UNITED STATES  
DEPARTMENT OF THE INTERIOR  
BUREAU OF LAND MANAGEMENT  
**APPLICATION FOR PERMIT TO DRILL OR REENTER**

1a. Type of work: <input checked="" type="checkbox"/> DRILL <input type="checkbox"/> REENTER 1b. Type of Well: <input checked="" type="checkbox"/> Oil Well <input type="checkbox"/> Gas Well <input type="checkbox"/> Other 1c. Type of Completion: <input type="checkbox"/> Hydraulic Fracturing <input type="checkbox"/> Single Zone <input checked="" type="checkbox"/> Multiple Zone		5. Lease Serial No. <b>NMNM30400</b> 6. If Indian, Allottee or Tribe Name  7. If Unit or CA Agreement, Name and No.  8. Lease Name and Well No. <b>LACEY SWISS 1 FED COM</b> <b>205H</b> 9. API Well No. <b>30-025-52777</b>

COA

Proposed Wellbore A

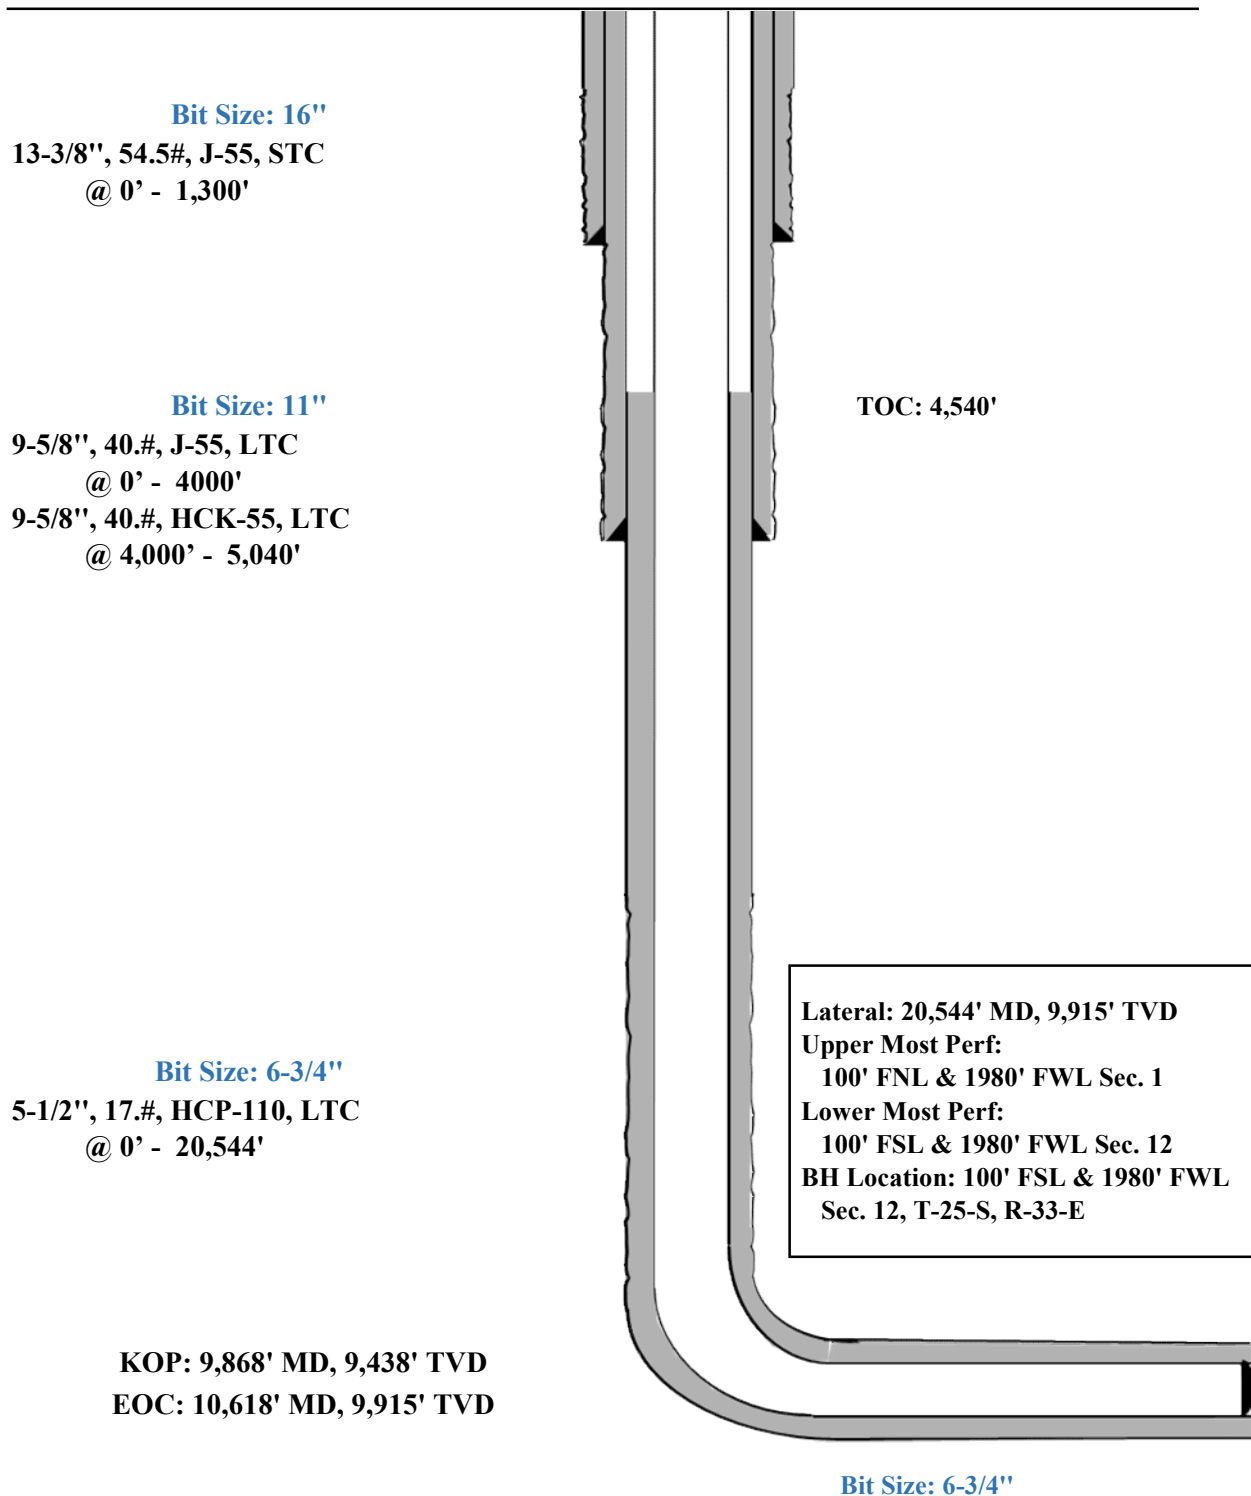
**Operator has proposed to pump down 13-3/8" X 9-5/8" annulus. Operator must top out cement after the bradenhead squeeze and verify cement to surface. Operator can also check TOC with Echo-meter. CBL must be run from TD of the 9-5/8" casing to surface if confidence is lacking on the quality of the bradenhead squeeze cement job. Submit results to BLM.**

**Bradenhead squeeze in the production interval is only as an edge case remediation measure and is NOT approved in this COA. If production cement job experiences losses and a bradenhead squeeze is needed for tie-back, BLM Engineering should be notified prior to job with volumes and planned wellbore schematic. CBL will be needed when this occurs.**

- Cement should tie-back at least 200 feet into previous casing string. Operator shall provide method of verification.

Proposed Wellbore B:

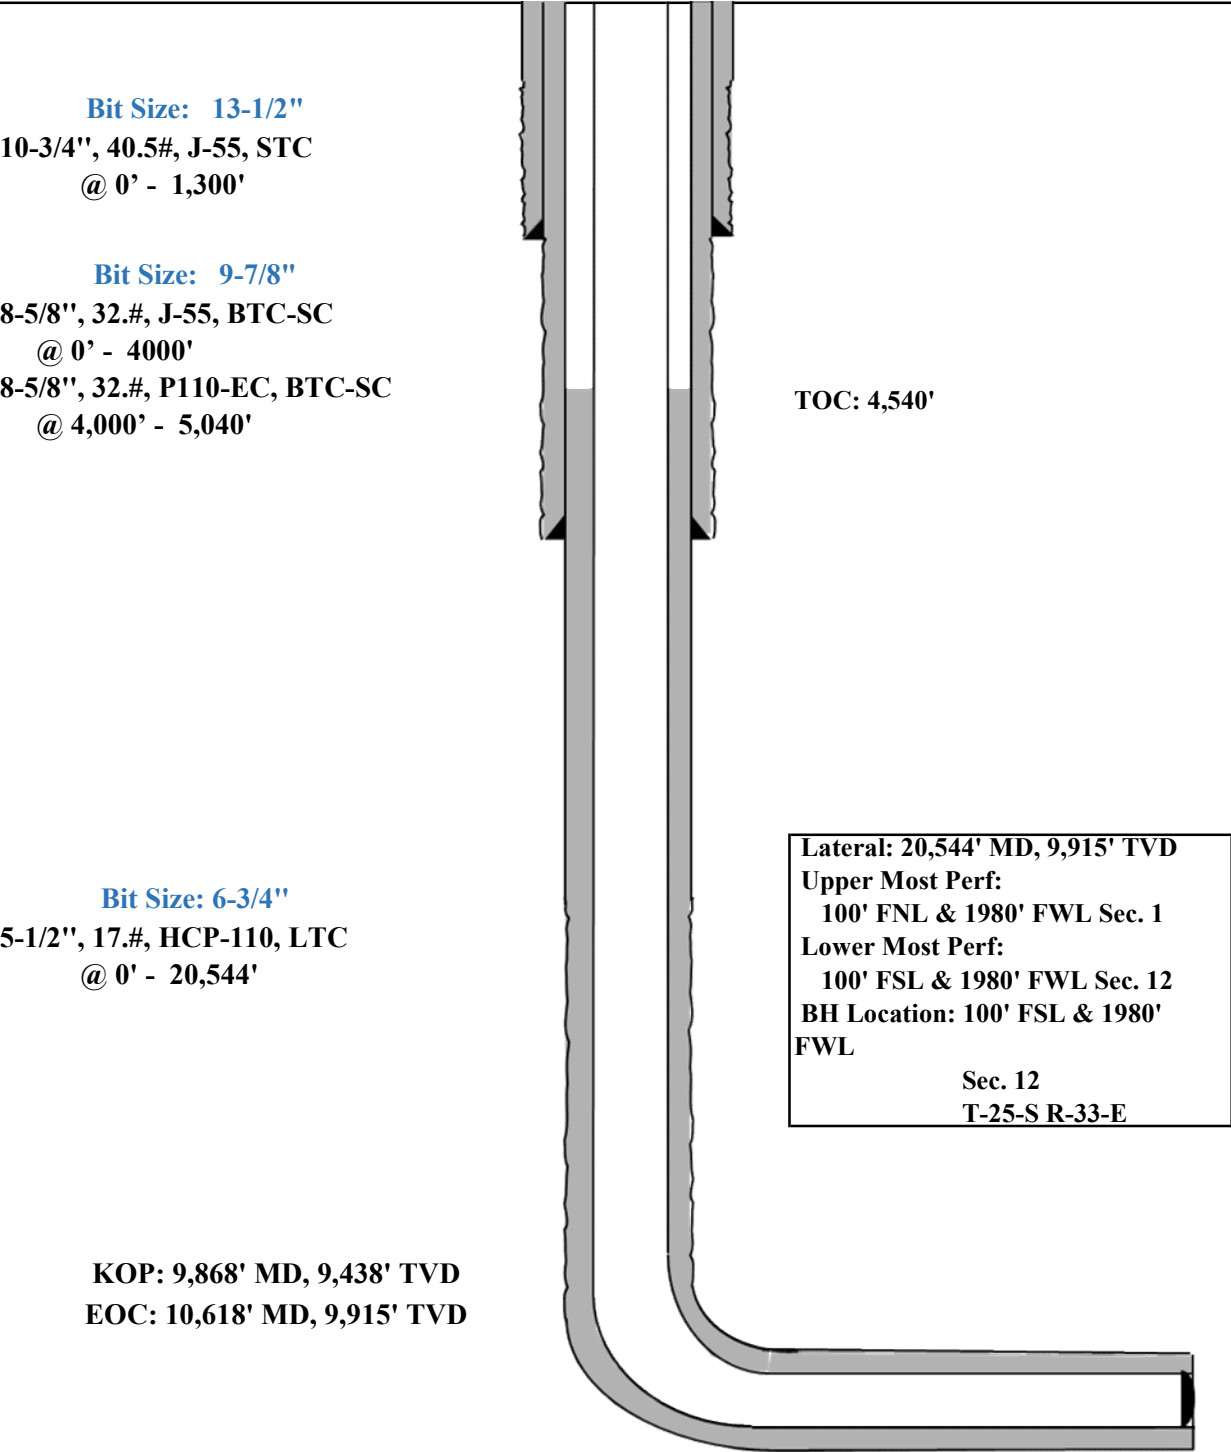
**Operator has proposed to pump down 10-3/4" X 8-5/8" annulus. Operator must top out cement after the bradenhead squeeze and verify cement to surface. Operator can also check TOC with Echo-meter. CBL must be run from TD of the 8-5/8" casing to surface if confidence is lacking on the quality of the bradenhead squeeze cement job. Submit results to BLM.**

**Bradenhead squeeze in the production interval is only as an edge case remediation measure and is NOT approved in this COA. If production cement job experiences losses and a bradenhead squeeze is needed for tie-back, BLM Engineering should be notified prior to job with volumes and planned wellbore schematic. CBL will be needed when this occurs.**

- Cement should tie-back at least **200 feet** into previous casing string. Operator shall provide method of verification.
